Vertex Wear Limited (Extension)

Vorari, Fulbaria, Hemayetpur, Savar
(23.8007927, 90.2526403)

17 December 2023

2. Observation

COLUMN SCHEDULE	
COL FLOOR	C1
BELOW GROUND FLOOR & UNDER ETP	 SIZE: 825 Ø BAR: 18-25Ø TIE: 10Ø@ 75mm Spiral
GROUND FLOOR & 1ST FLOOR	 SIZE: 750 Ø BAR: 18-25Ø TIE: 10Ø@ 75mm Spiral

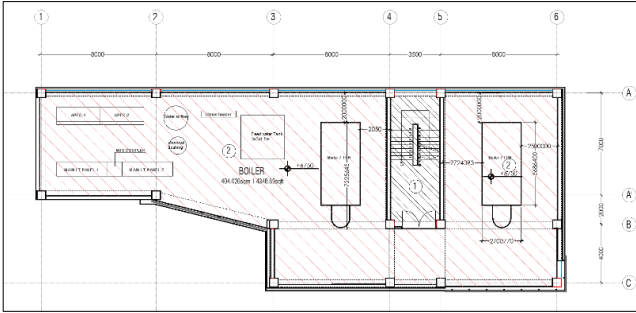
Description: In the design report, design concrete strength has been considered 4500psi for the column. During inspection only two sets of the cylinder test report were available for the column where one set was found without average value. The number of cylinder test reports do not satisfy the frequency of test as per BNBC. Building engineer is required to verify the in situ concrete strength.

The circular columns' clear height found 11.37m and the diameter of the circular column is 750mm. the columns seems to be slender that needs to be addressed in design report.

Building engineer is required to revise the design documents based on in-situ material strength and lateral loadings based on actual site condition.

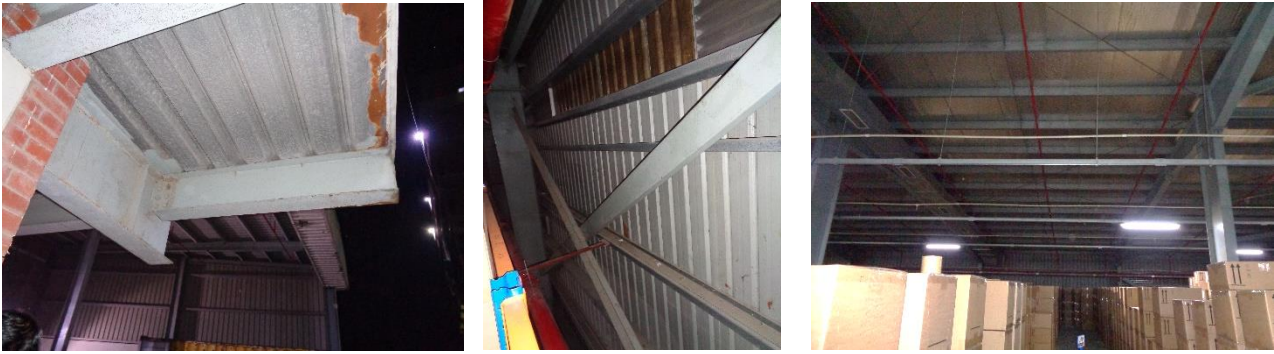
The number of re-bars for the C1 column found mismatch in at 1st floor.

Building engineer is required to revise the design documents based on in-situ material strength and lateral loadings based on actual site condition.
